Site Instruction

Project Name: AQUAVISTA - Bayside

SI No.: E 034

Title: Revision – PV System

RESIDENTIAL CONDO POWER DISTRIBUTION RISER DIAGRAM
N.T.S.

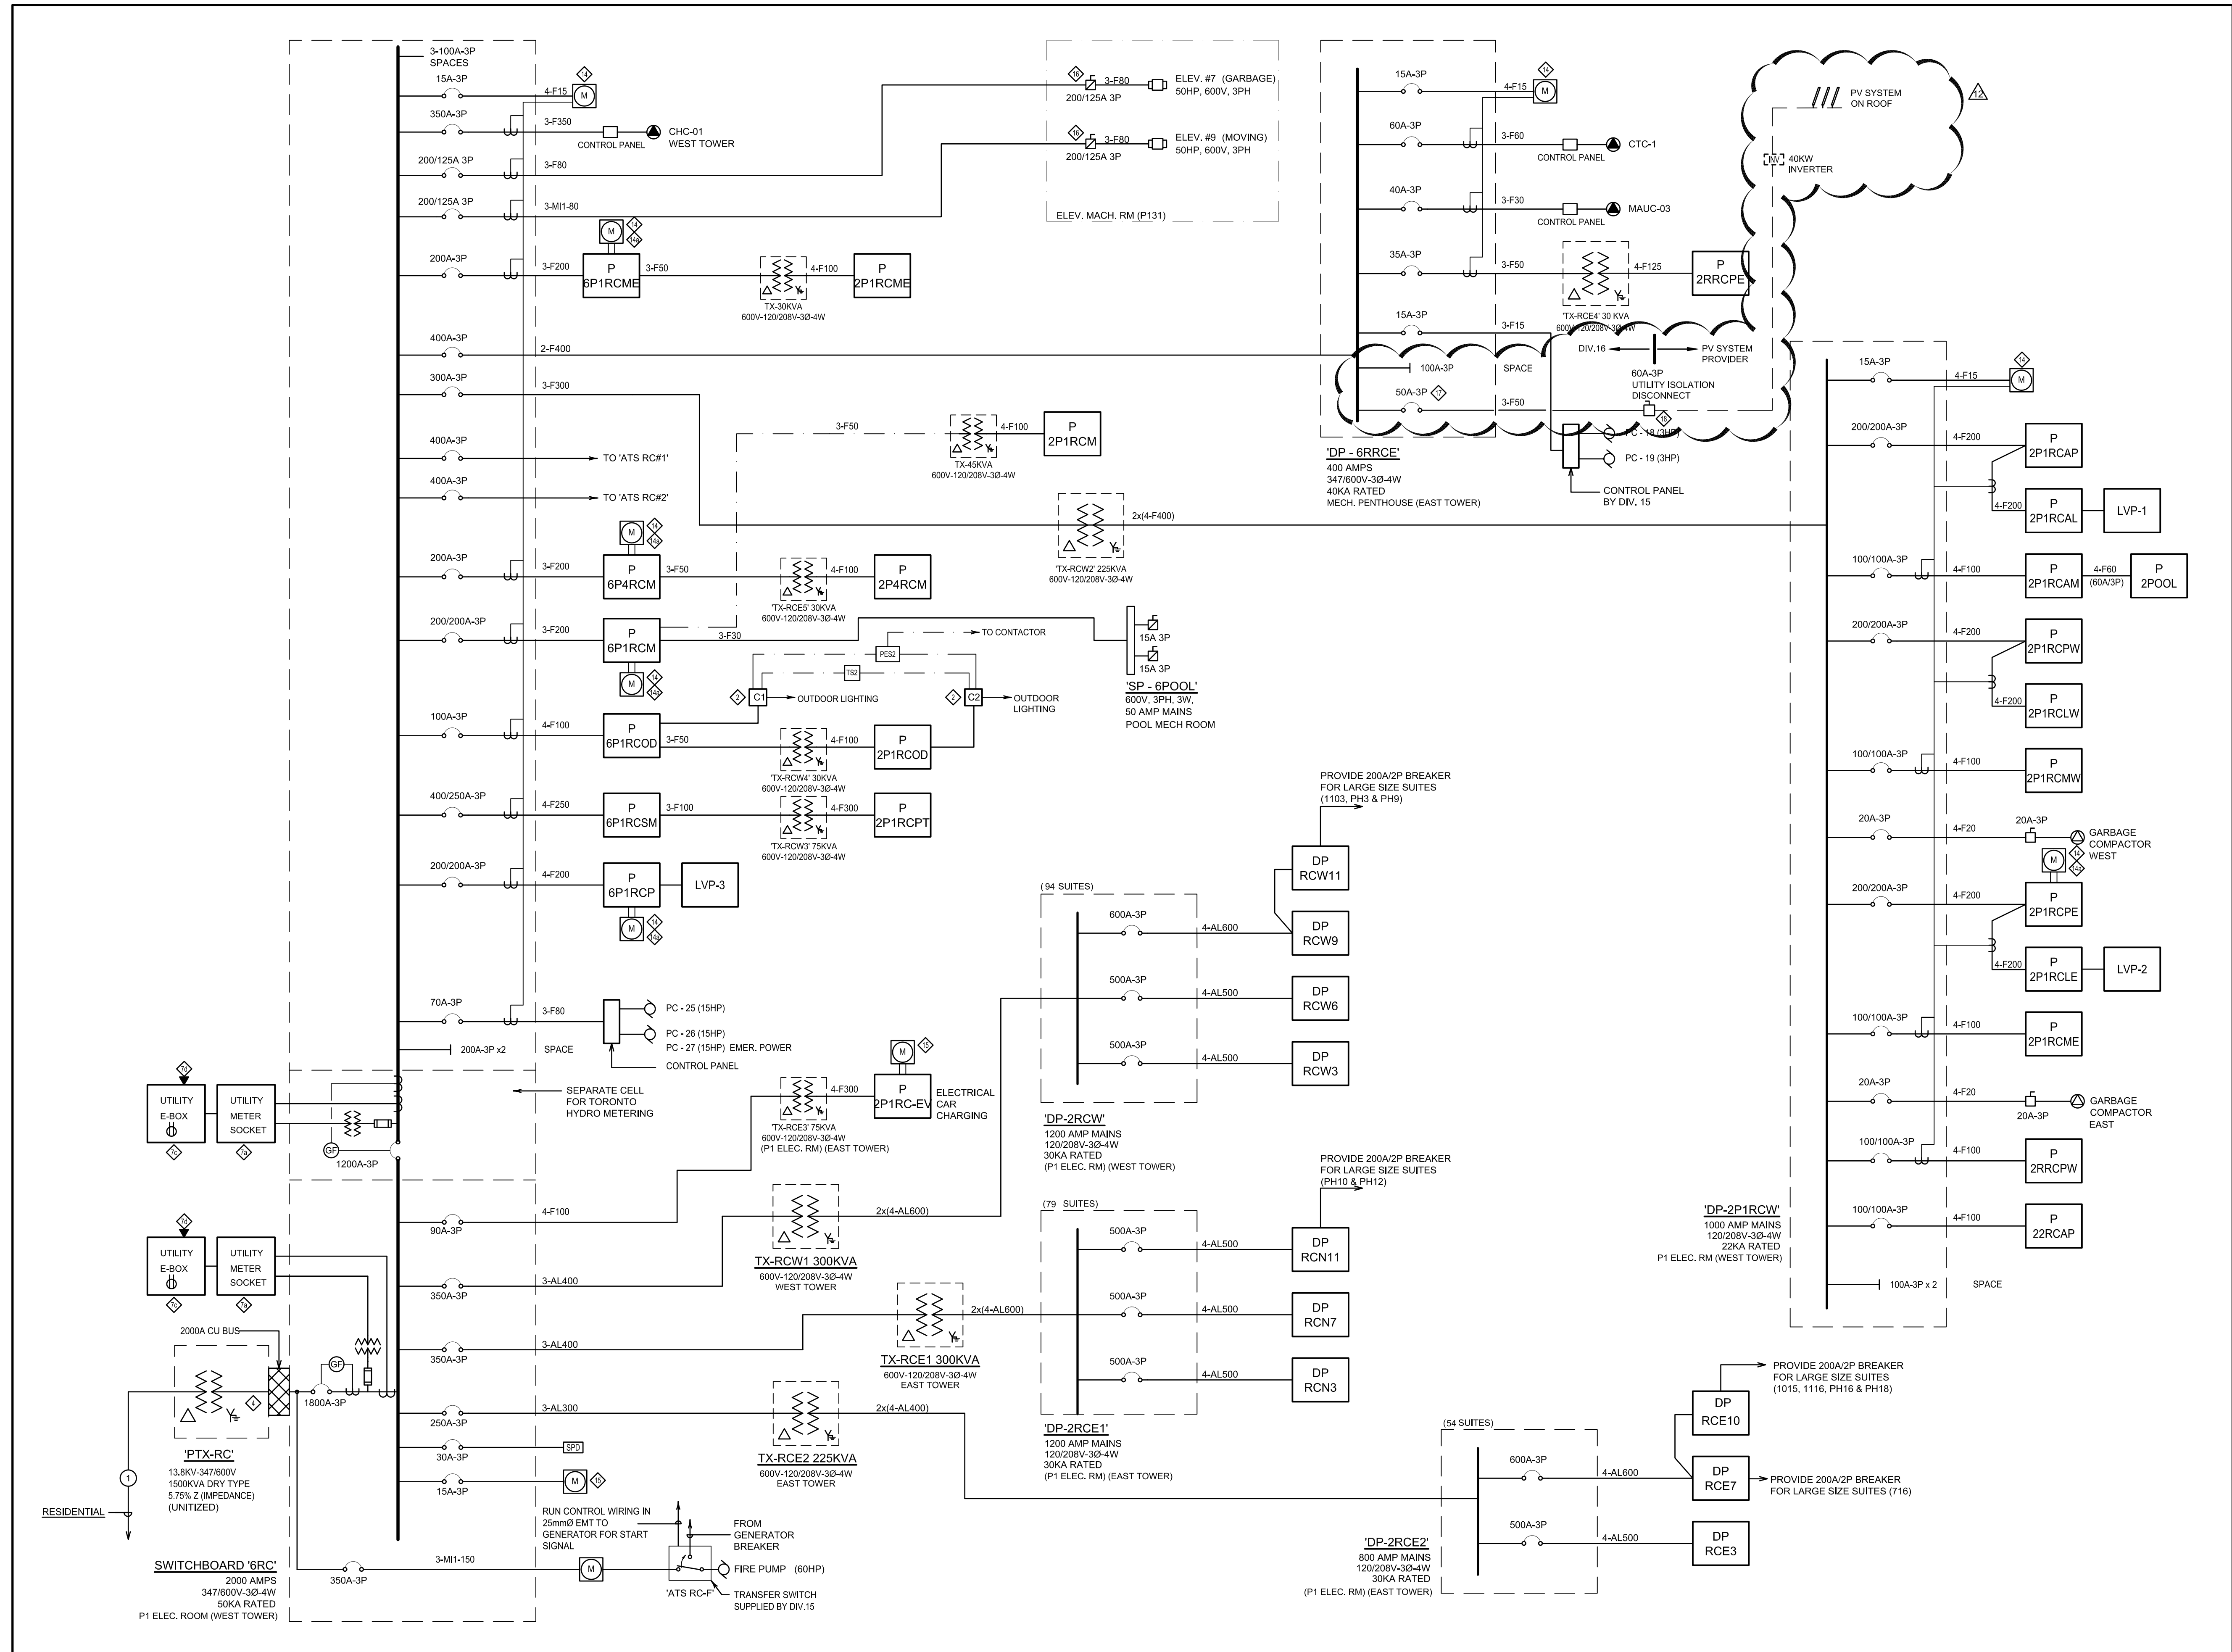
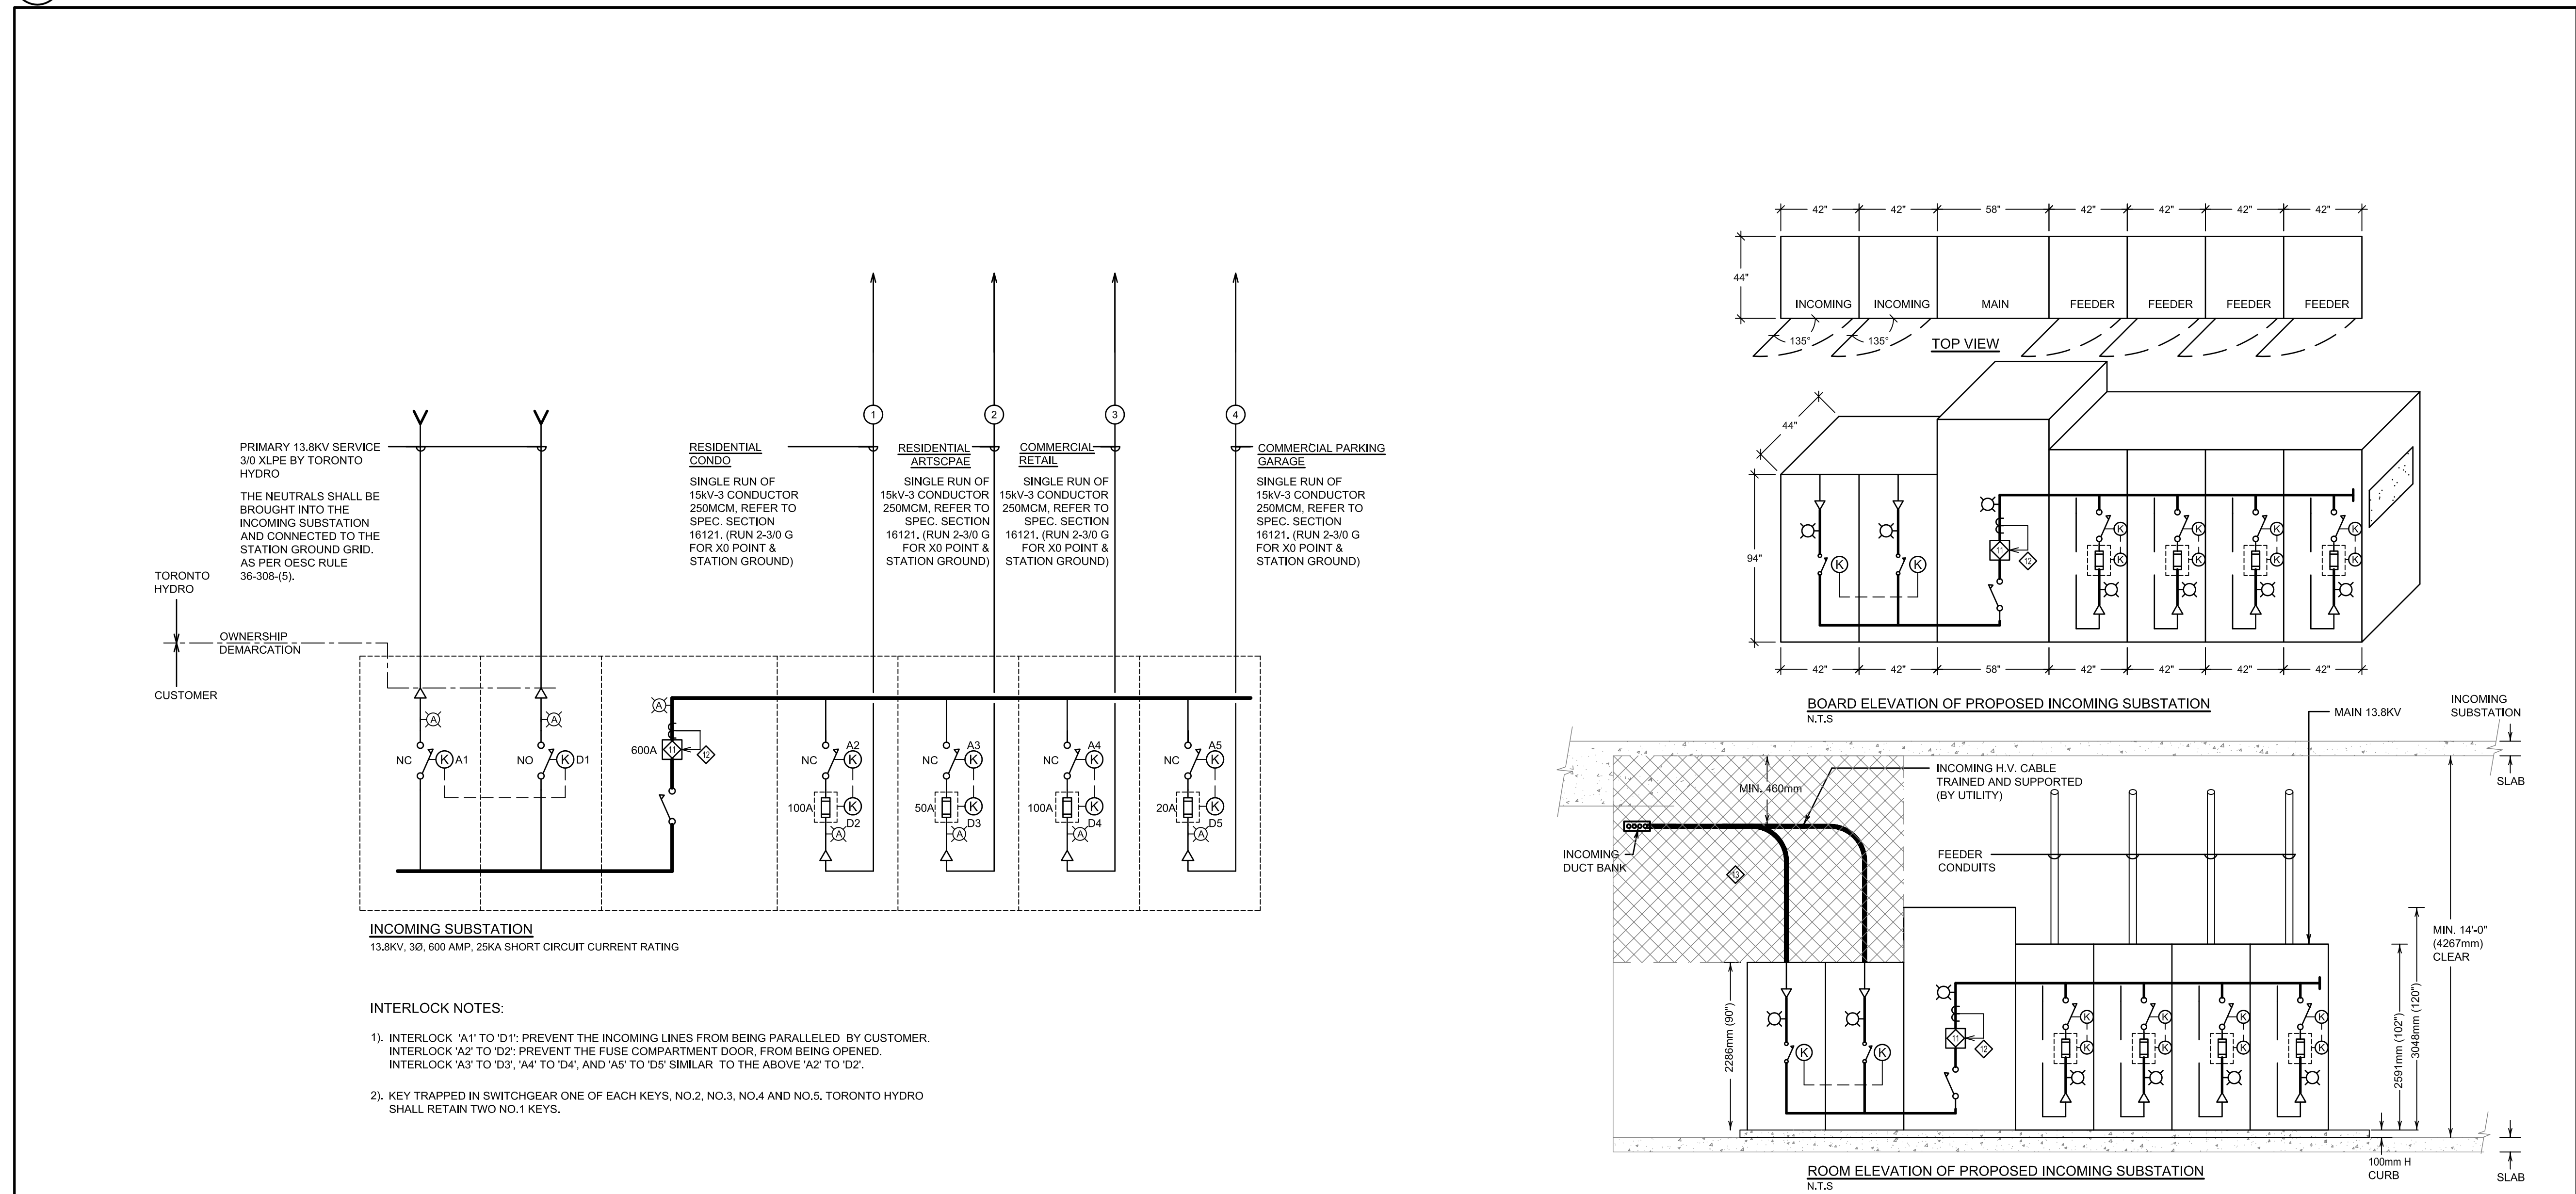
Drawing No.	Drawing Issued	Items
E3-01-RC	Yes	Add 50A, 3P breaker on panel DP-6RRCE and 60A, 3P utility isolation disconnect for the PV Inverter connection as shown on the drawing.
